# HILLSIDE NURSERIES, BURY

# PLANNERS' FEEDBACK OF INITIAL SCHEME

# INITIAL COMMENTS TAKEN AT THE PRE APP MEETING WITH THE PLANNERS

# FORMAL ECE REVISED SITE PLAN TO ADDRESS INITIAL PLANNERS COMMENTS

# PLANNERS' FEEDBACK OF INITIAL SCHEME

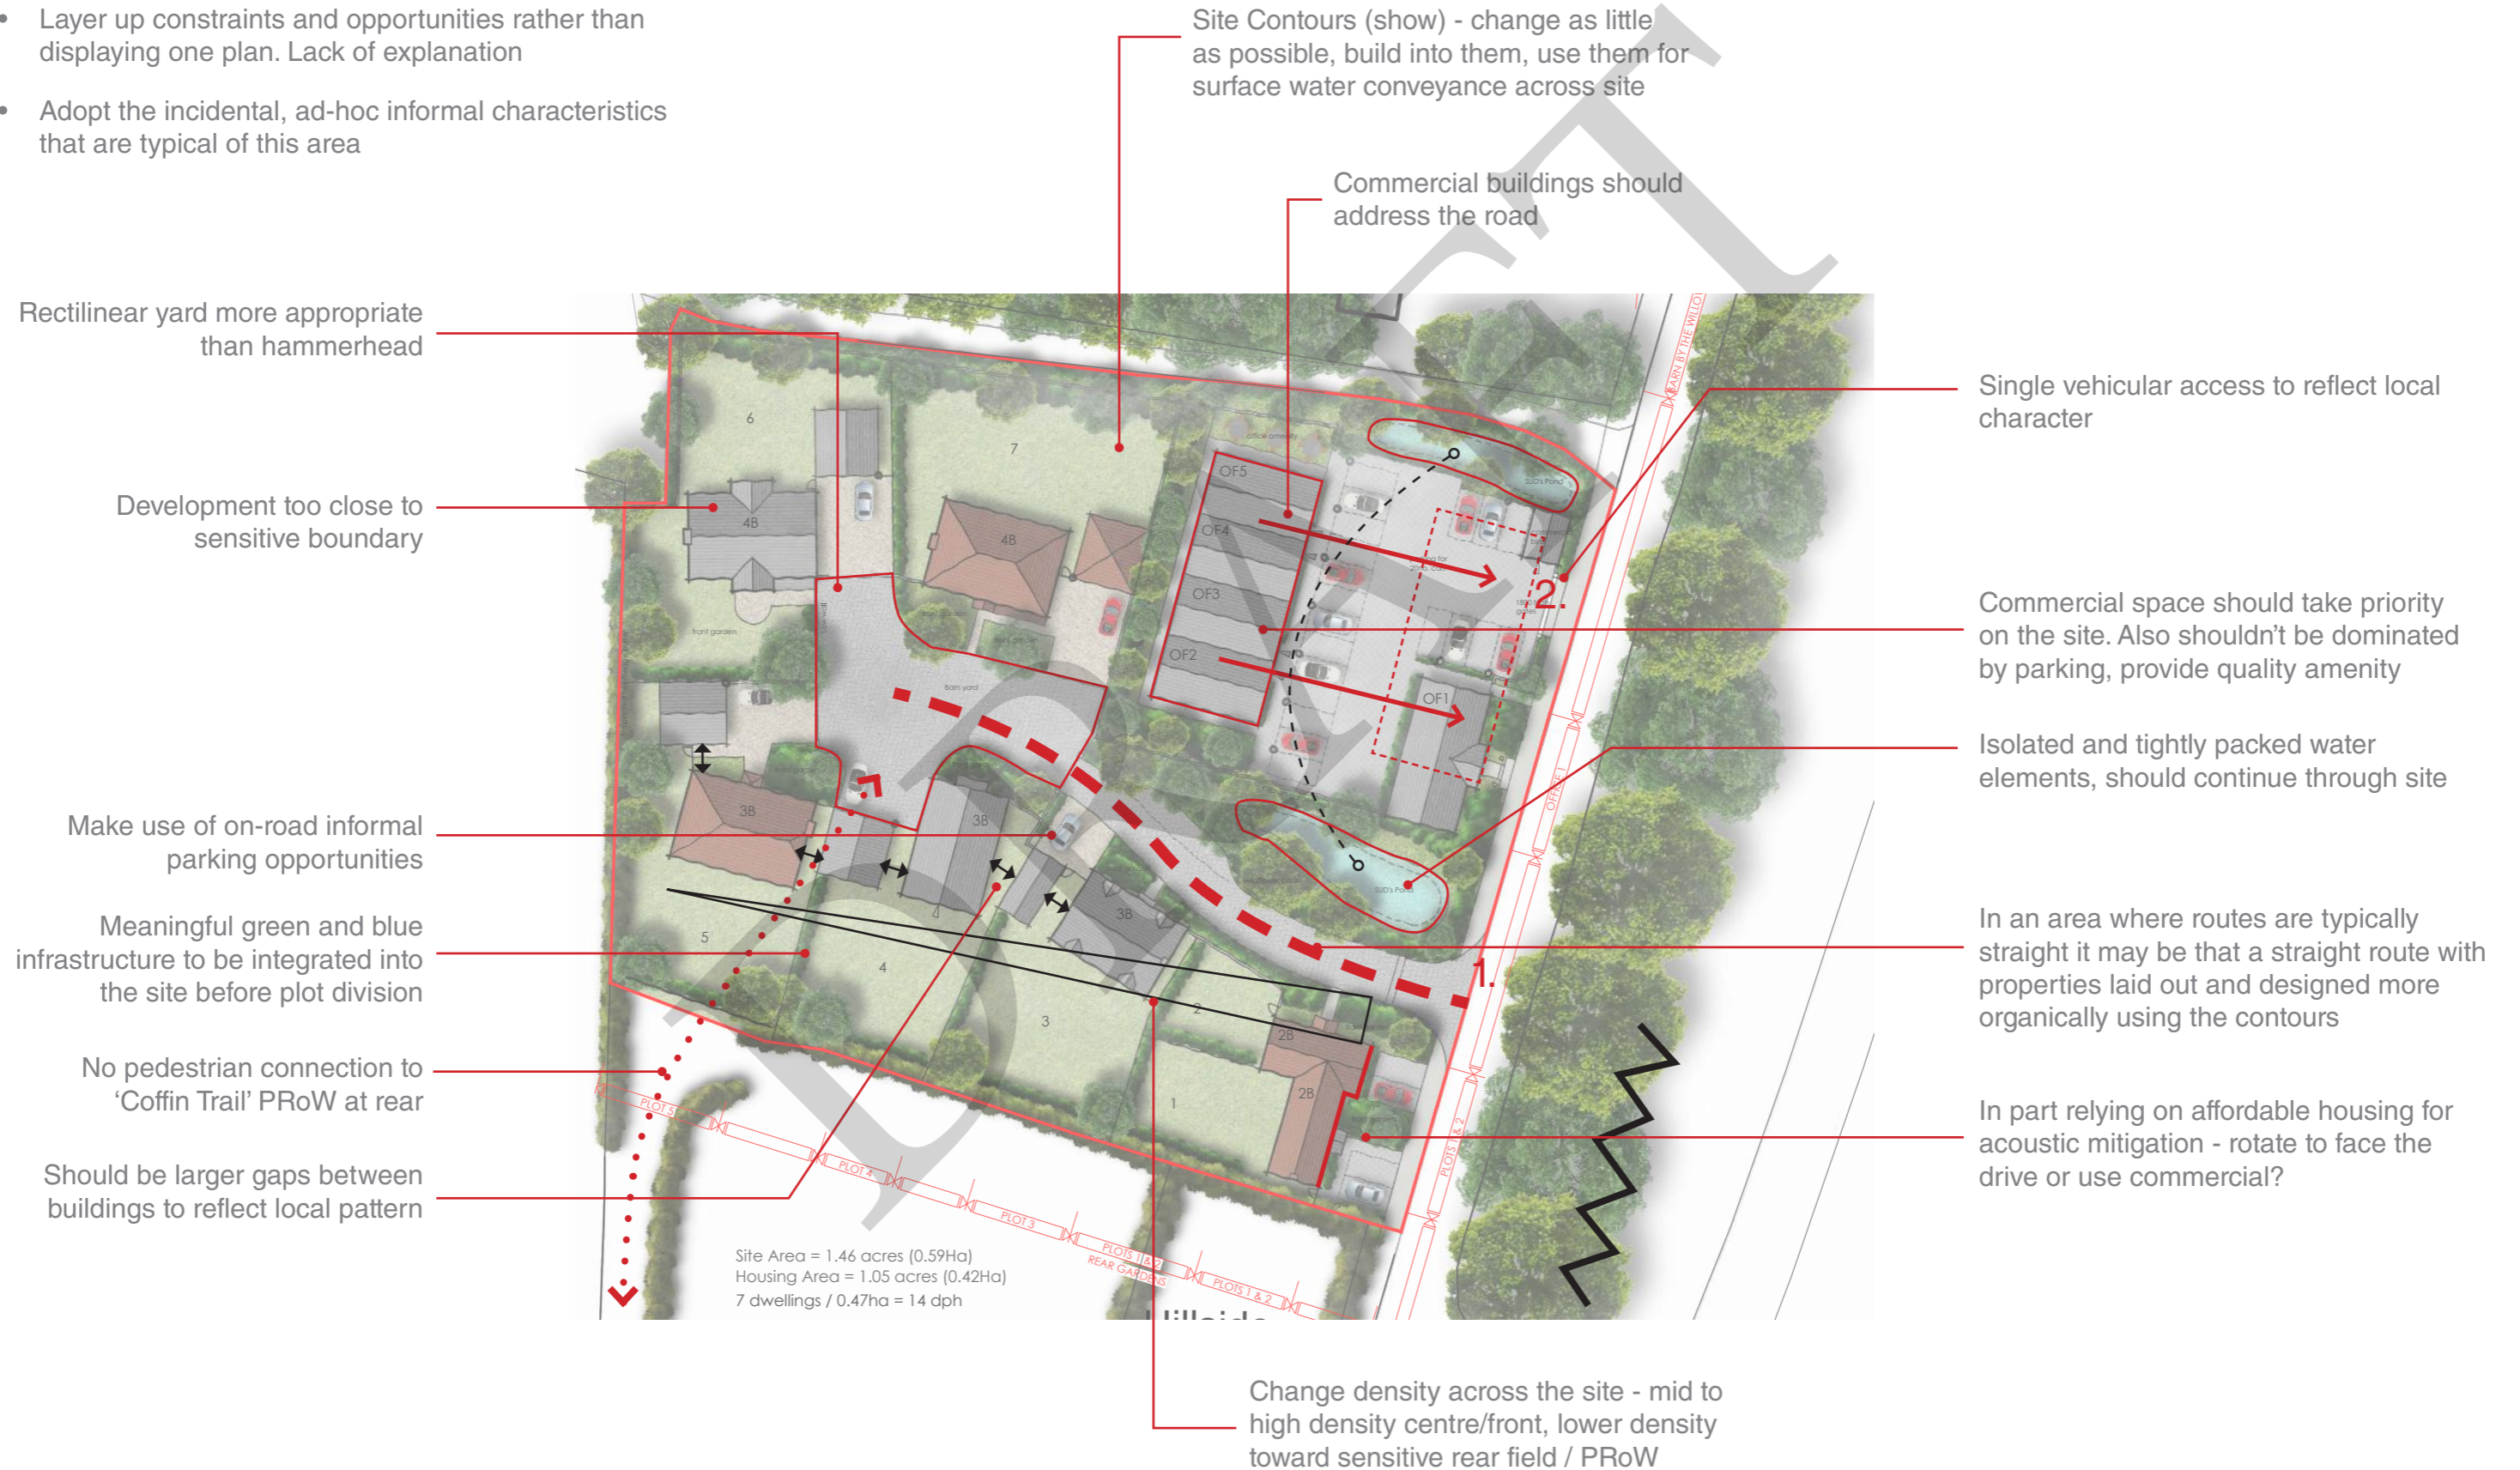
No landscape strategy/concept design has been produced.

Most dwellings are positioned against the contours of the site.

Join up habitats and incorporate meaningful GI within the site.

There is too much development on the western edge.

**The layout is very suburban due to the cul de sac road, large houses and garages and front driveways.**

Buildings are too close to each other, not having wide gaps between each other, which is characteristic of the area, where views of the surroundings and greenery is available between plots/buildings.

The office block runs against contours, raising the building's mass on the public realm. This building is large in footprint and should better respond to building sizes that are characteristic in the area. The L shape is positive as it encloses the employment area from road and residential uses, but results in an excessively large building.

There is an excessive use of roof lights on all buildings. Internal light transmission would have a detrimental impact on the dark night skies of the SDNP and therefore these should be removed and minimised where possible. Roof habitable/office space should be reconsidered. Other large first floor openings and large elevational openings facing open countryside would not be supported either.

**The size of garages is disproportionate and contribute to an over development of plots and the whole site.**

The proposed access and road is too wide, suburban in character due to its size, cul de sac typology and standard sized verges and vehicle parking. It is overly designed in a suburban manner and does not reflect the routes characteristics found in Bury: narrow routes, enclosures and buildings abutting the line of the routes, green informal verges, nature hedgerows and trees.

The site currently counts with two accesses (east and west), but the west access is proposed to be closed. This is very disappointing as it could serve as a secondary access for some dwellings only, or to provide a pedestrian way through the site to the public right of way beyond. Improving the permeability of the site is important, as well as providing direct access to residents/workers to the countryside and an opportunity is missed here.

28 parking spaces for residents and visitors is disproportionate and makes an inefficient use of land, exceeding the Parking SPD calculator requirements for this type of development (24 spaces). It would be recommended to prioritise more sustainable travel options in the design, including parking provision, and making a more efficient use of land, which could be put for better use.

# SITE SKETCH SECTIONS

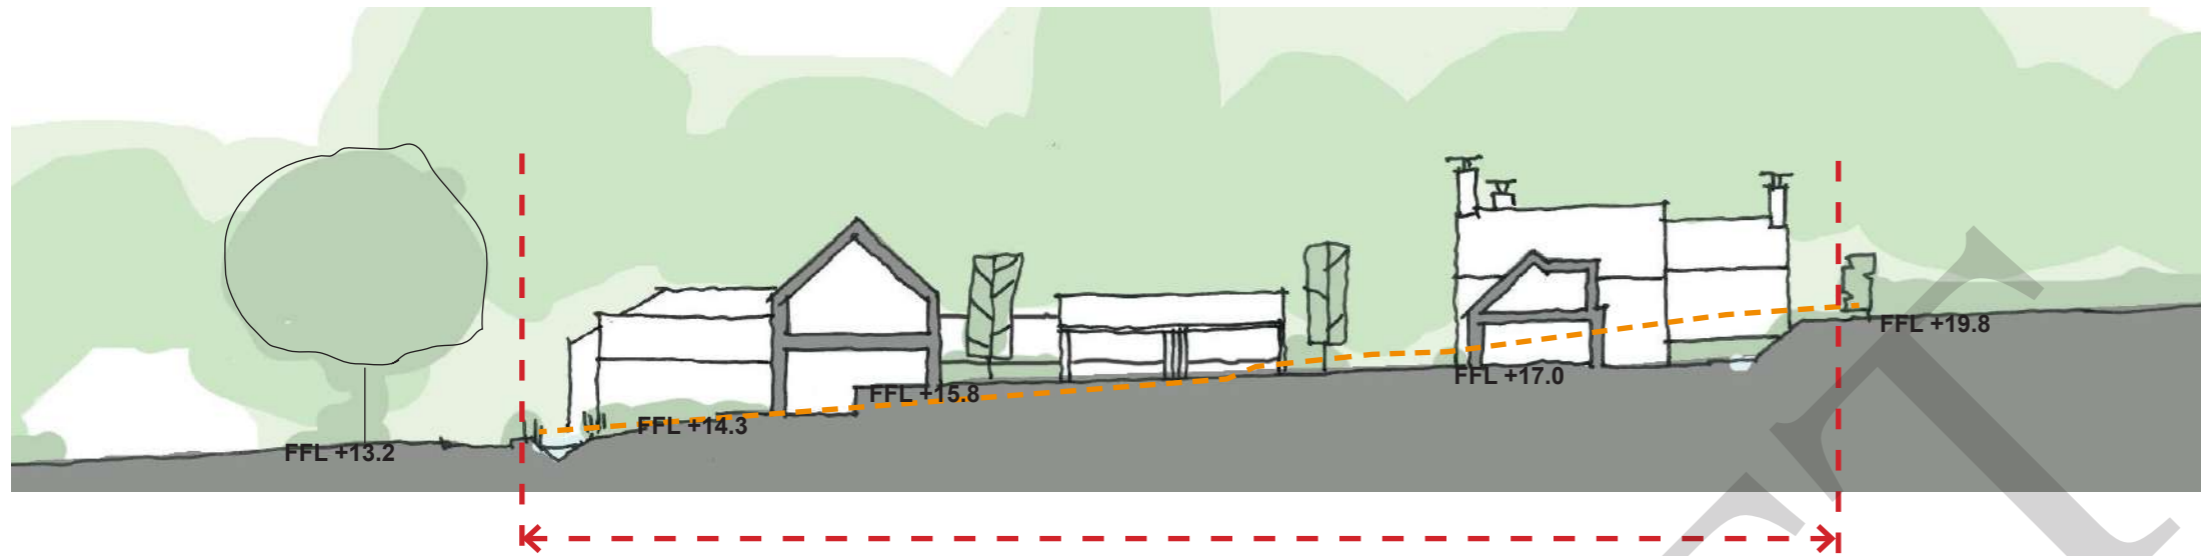
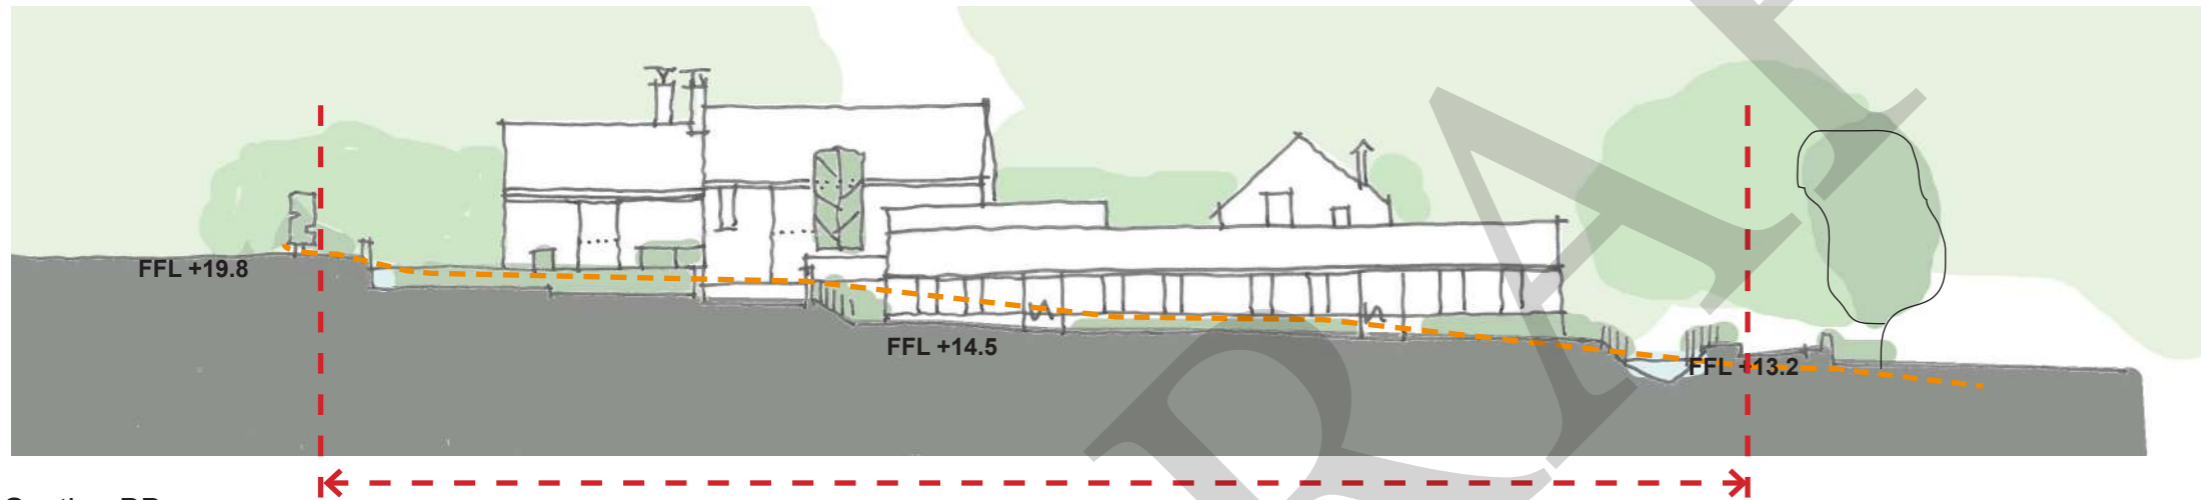
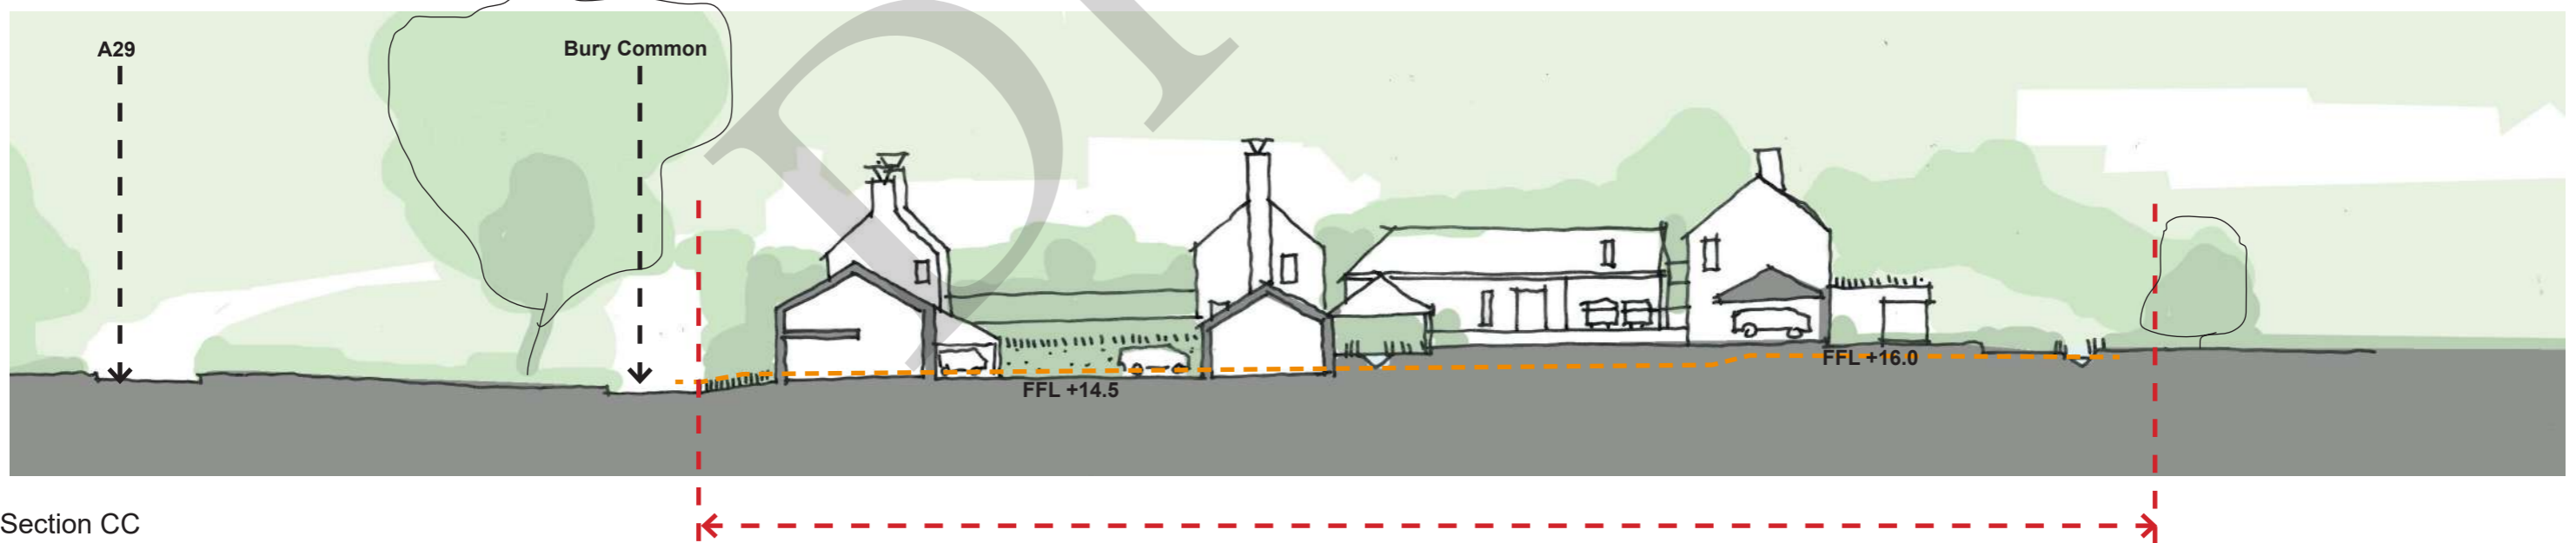
As you identify, a positive response to the levels will be critical throughout all elements of the scheme. Yes a hierarchy is important but at present looking at the sections, the residential bulk still dominates so I would recommend a further change of emphasis, including more larger and prominent commercial buildings, with length broken up to suit the contours (not a long range built up significantly at one end as is currently indicated).
